Attachment D

**Re: Proposed Official Plan Amendment OPA 21/11 and
Zoning By-law Amendment ZBA 21/017
146-162 Victoria Street South and 92-110 Park Street
GSP Group (C/O Kristen Barisdale) on behalf of DOV
Capital (C/O Steven Ruse)
CITY OF KITCHENER**

City of Kitchener
ZONING BY-LAW AMENDMENT COMMENT FORM

ZONING BYLAW AND OFFICIAL PLAN AMENDMENT COMMENTS

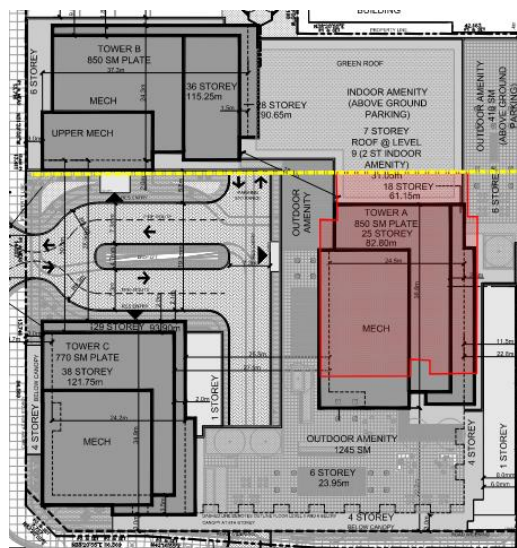
The primary view between towers B and C (see image below) to the site is to be considered as a focal point and a potential public art location or have upgraded cladding as it is above grade parking. Vision glass into the parking garage is not acceptable.
